C/0 SC 0 P1 L1 # i-38					
nslow, Peter Ciena Corporation	Grow, Robert Knowledge Developme					
Comment Type ER Comment Status D	Comment Type E Comment Status D					
The draft contains numerous Editor's notes regarding publication order.	2nd MEC requested review for front matter for being current.					
Now that the assumed publication order is decided, these should all be removed.	SuggestedRemedy					
SuggestedRemedy Remove all such editor's notes and modify the draft (if necessary) to account for the publication order: IEEE P802.3bw - Amendment 1	We somehow lost the bottom of page 2 boilerplate, restore. Copyright paragraph on title page disagrees with IEEE FrameMaker templates which disagrees with the style manual refer to publication editors for answer on which is most current.					
IEEE P802.3by - Amendment 1	Proposed Response Response Status W					
IEEE P802.3bg - Amendment 3	PROPOSED ACCEPT IN PRINCIPLE.

Page 1 of 15 9/9/2016 5:54:07 PM

C/ 115 SC 115.2.4.3.2

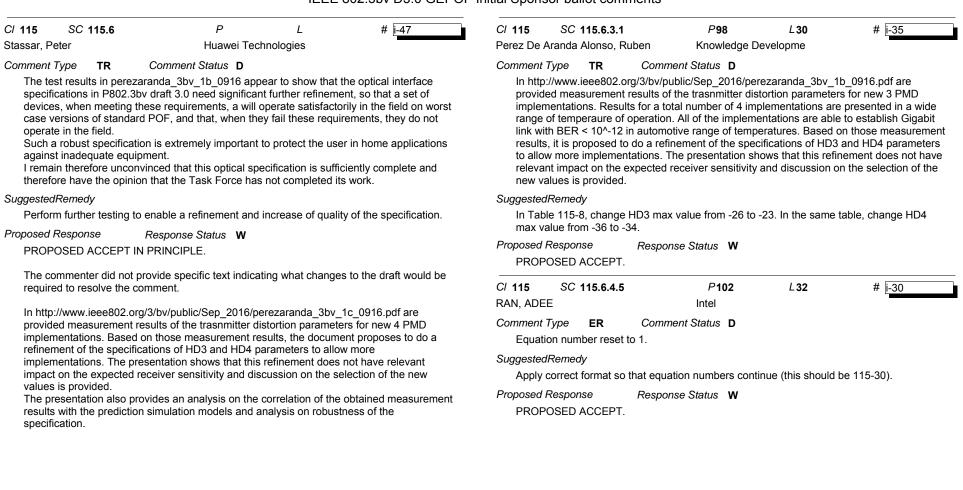
115 SC 115.2.1 P48 L29 # i-21 AN, ADEE Intel	C/ 115 SC 115.2.4.1 P53 L32 # i-32 RAN, ADEE Intel
omment Type T Comment Status D	Comment Type T Comment Status D
It is not obvious from this figure where the PMA starts.	"Shall be" is inappropriate for a nominal bit rate; the bit rate is derived from the GMII clock frequency.

115.3.1 says that the THP encoder (and implicitly decoder too) is part of the PMA, so at the interface to the PMA the payload data path is encoded as PAM16 symbols.	SuggestedRemedy Change "shall be" to "is" and delete the corresponding PICS item.
In addition, the PMA function is to serialize the transmit block provided by the PCS; describing it as a multiplexer between data paths would require each of these data paths to pause or insert dummy symbols when not selected.	Proposed Response Response Status W PROPOSED ACCEPT IN PRINCIPLE.
uggestedRemedy	Having PDB in the sentence is somewhat confusing and not really needed for
Arrange Figure 115-5 somewhat differently:	understanding. Editor to replace whole sentence with:
Show the PMA as a distinct rectangle, with the power scaling sub-blocks included, as well as the THP block. (currently there is a shaded polygon, it is not clear that this is the PMA)	"The nominal bit rate of the output of the 64B/65B encoder is (65/64) \times 1000 = 1015.625 Mb/s."

Show the PCS as a separate rectangle including all PCS sub-blocks, with the interface	Delete the corresponding PICS item PCS17.
being a transmit block (as defined in 115.2.1).	C/ 115 SC 115.2.4.3.2 P60 L20 # i-25
Change the label inside the PMA from "multiplexer" to "serializer".	RAN, ADEE Intel
roposed Response Response Status W	Comment Type TR Comment Status D
PROPOSED ACCEPT IN PRINCIPLE.	In Equation (115-6), s1 appears as a factor of both x and x^2 . This seems incorrect.
The description as a multiplexer in the figure 115-5 is considered consistent with the	SuggestedRemedy
intended function that really wants to be specified and with the figure 115-4. However, if we describe it as serializer, it may confuse to the reader that can think that a parallel to serial	Change the factor of x ² to s2.
transformation has to be implemented, whis is not true. Because of that, the block named multiplexer should stay.	Proposed Response Response Status W PROPOSED ACCEPT.

Editor to implement the changes of figure 115-5 per comment i-23 to be more consistent with the text and the figure 115-3. Copied here from response to i-23: + Move the Multiplexer block to the PCS sublayer + Do rectangle covering all the PCS subblocks + Reduce the PMA to a rectangle (no shaded polygon) containing 2 sub-blocks, THP and Power Scaling, back to back connected and arrow. + Arrow from PCS's multiplexer to THP in PMA + Arrow from Power scaling to PMD. (As it is specified in the PMA Transmit function, the THP is bypassed when pilots or PHD sub-blocks are transmitted, and the power scaling affects with different scaling factor as a
